RE: **Contract No. NB-630-000-006**
Administration Building Additions and Rnovations
Nice Bridge

ADDENDUM NO. 3

TITLE: Administration Building Addition and Renovation

FACILITY: Nice Bridge

NICE BRIDGE ADMINISTRATION BUILDING HVAC PROJECT
 ADDENDUM - I; DRAWING M-5; SKETCH-6

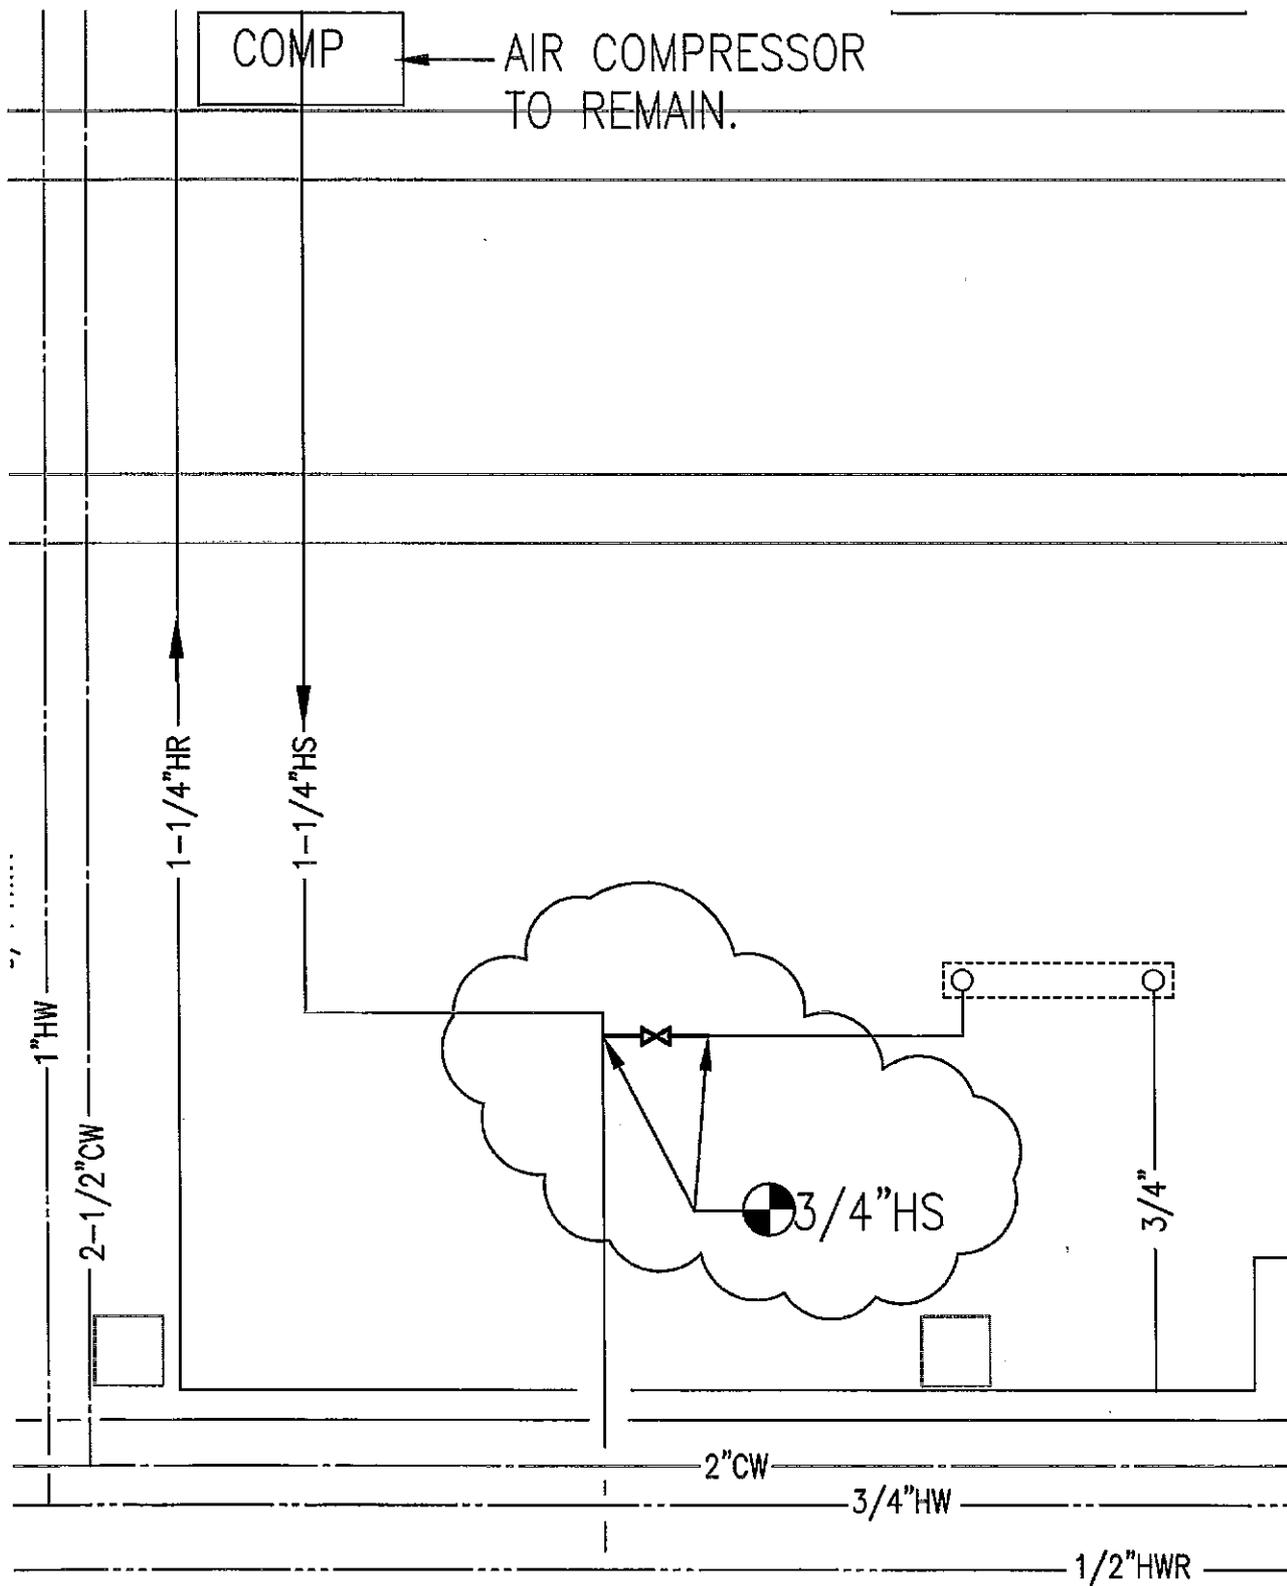
4. Add Note 19 to read as-
“Provide 4” high concrete pad extending a minimum of 6 inches on all sides of the boiler.”
5. Delete Convactor And reconnect piping to existing 1 1/4” HS as indicated in attached M-5, sketch 6.
- 6 Extend 3/4” ns and 3/4” nr pipe serving convector in storage room 118 above to new
- 7 location as indicated in attached M-5, sketch 6.

HOLDING CELL PLUMBING CHASE SANITARY PIPING ELEVATION

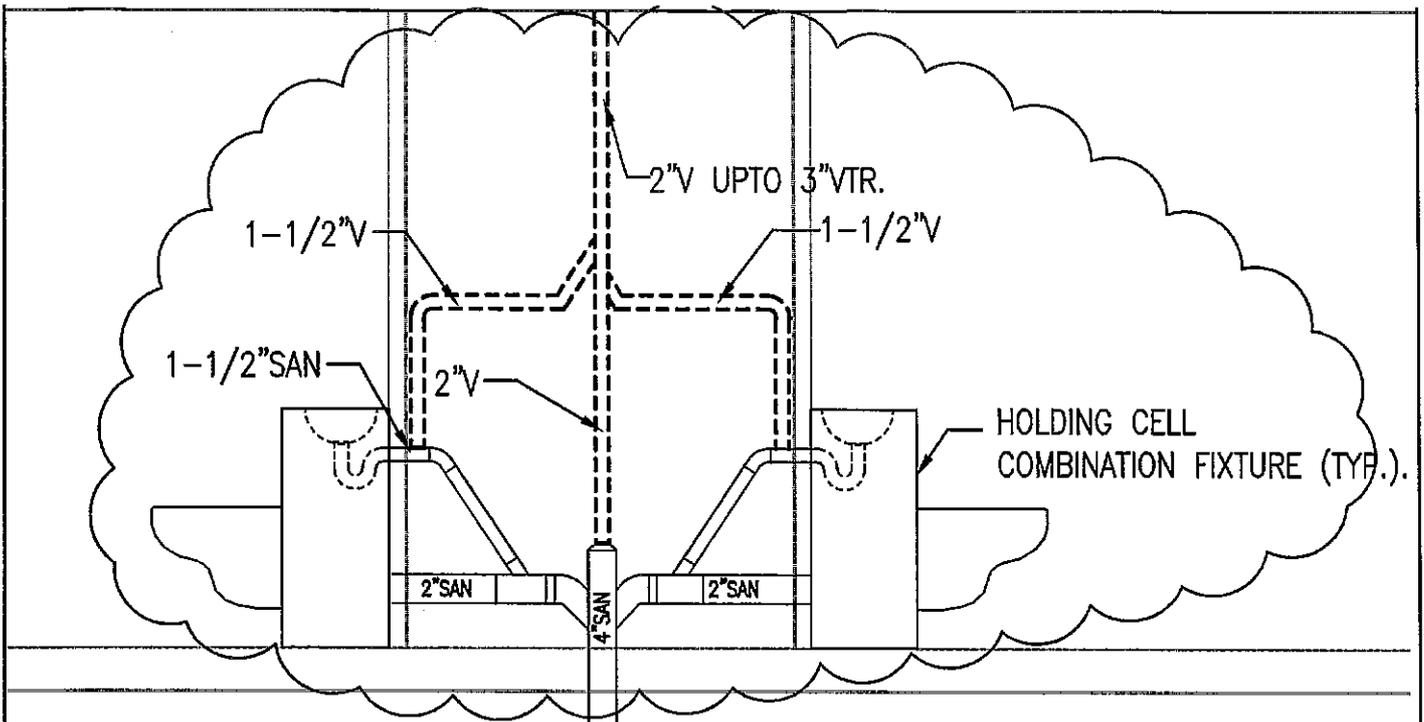
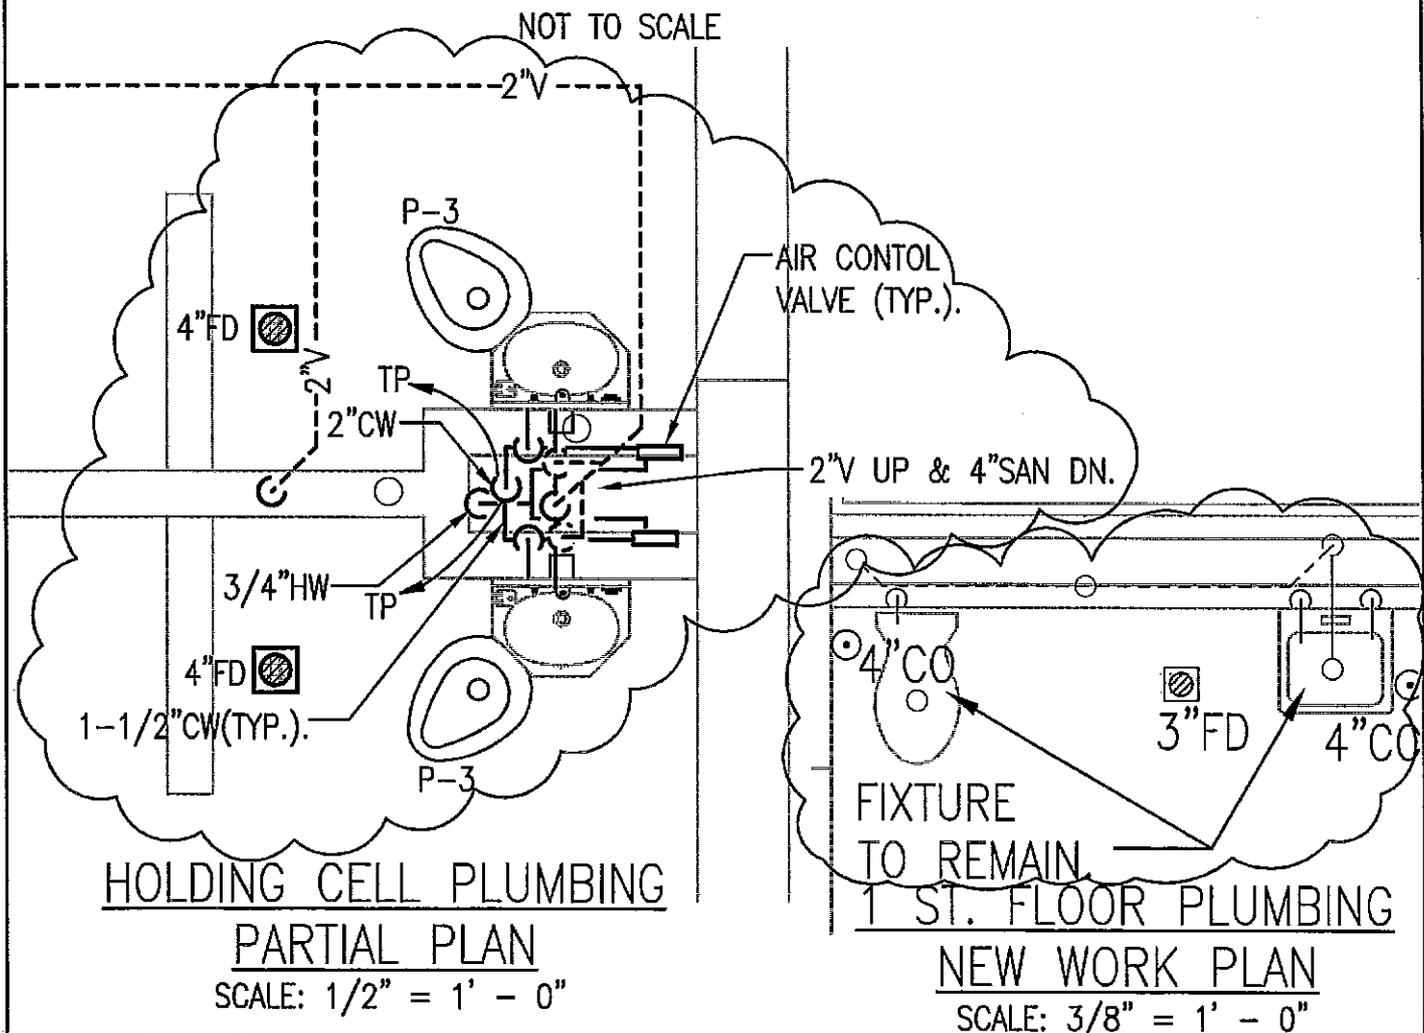
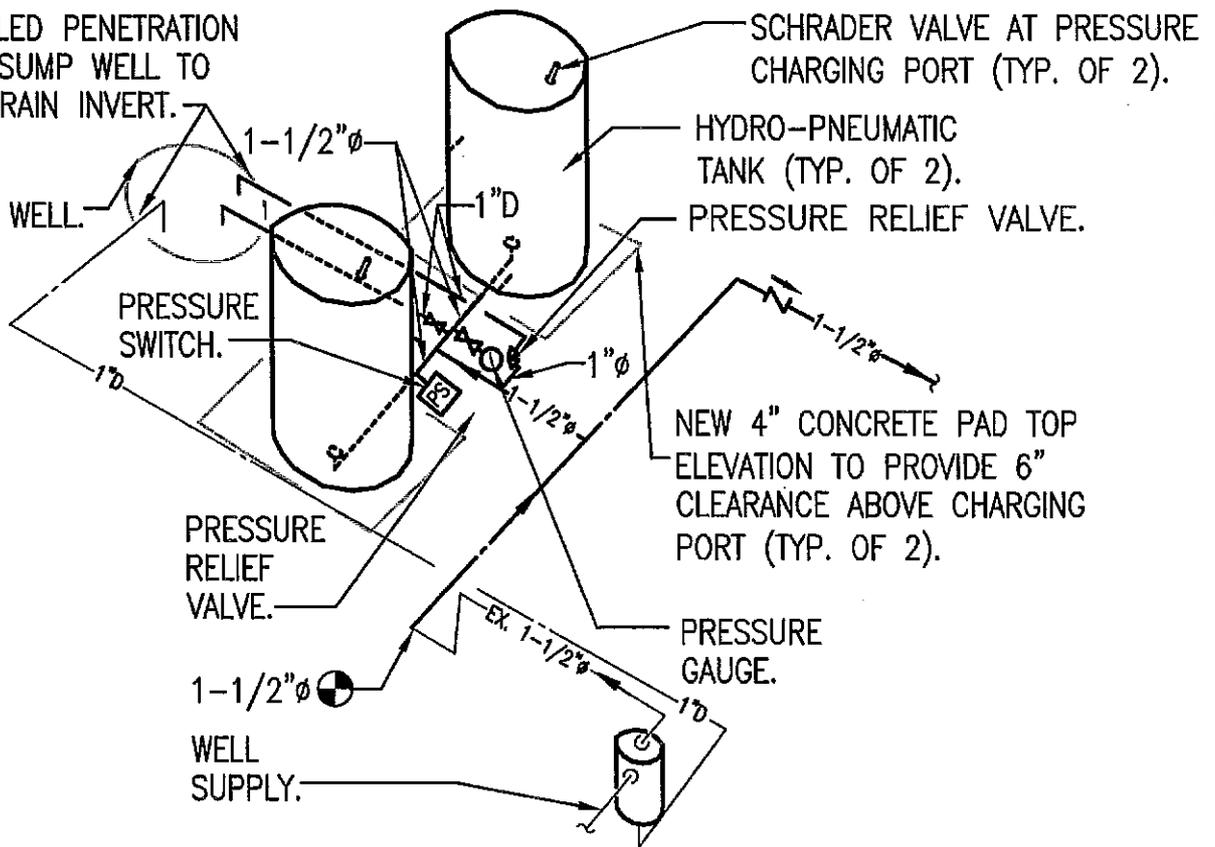
1. Revise First Floor Pumbing Plan, Holding Cell Plumbing Plan and Elevation as indicated in attached M-6, sketch 7.
2. 2” FD In Corridor To Read As 3” FD.

NICE BRIDGE ADMINISTRATION BUILDING HVAC PROJECT
 ADDENDUM - I; DRAWING M-9; SKETCH-8

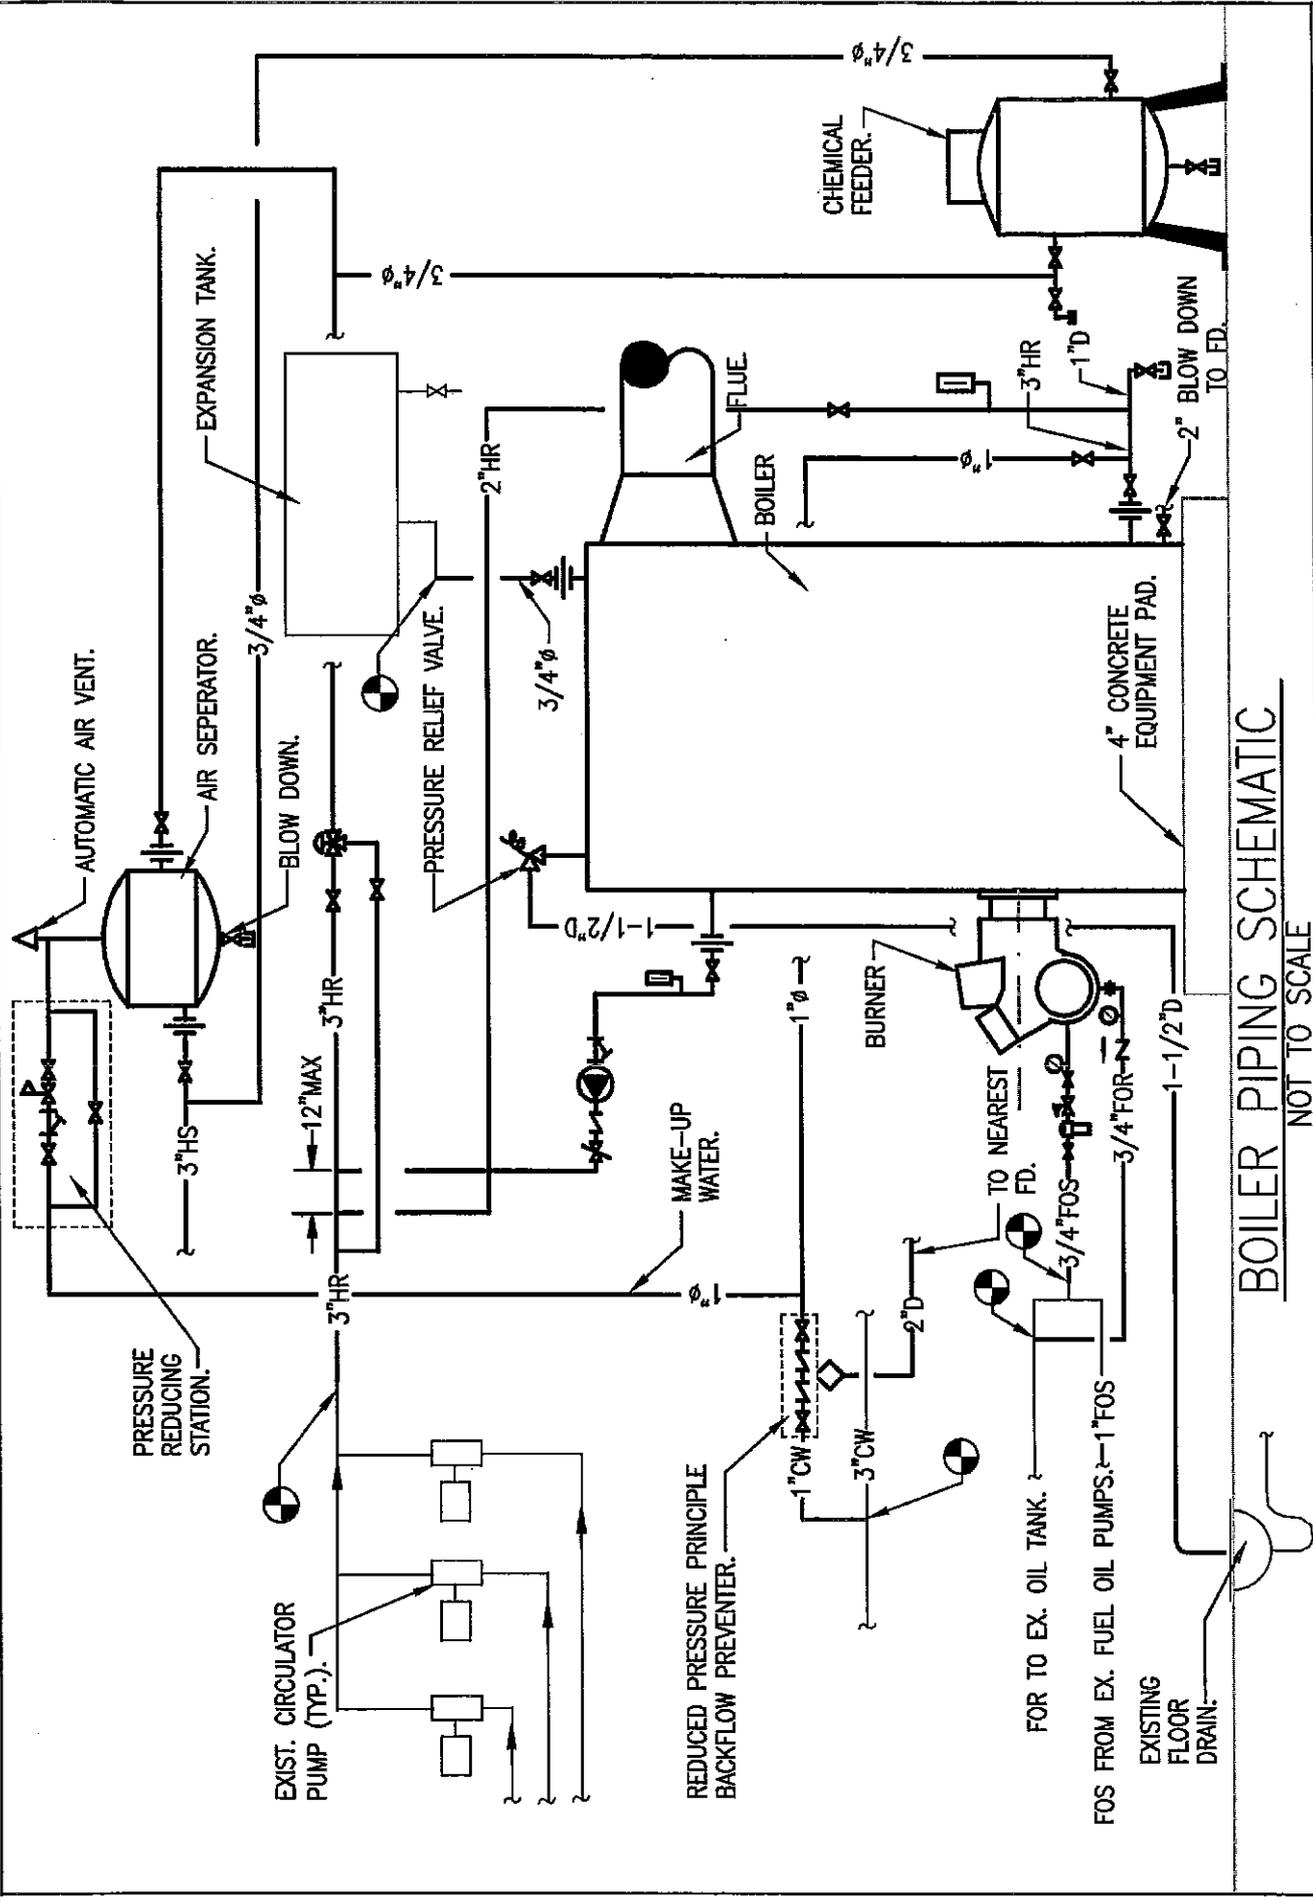
1. Revise Boiler Piping Schematic as indicated on attached M-9, sketch 8.
2. Revise Hydropneumatic Tank Piping Schematic as indicated on attached M-9, sketch 9.
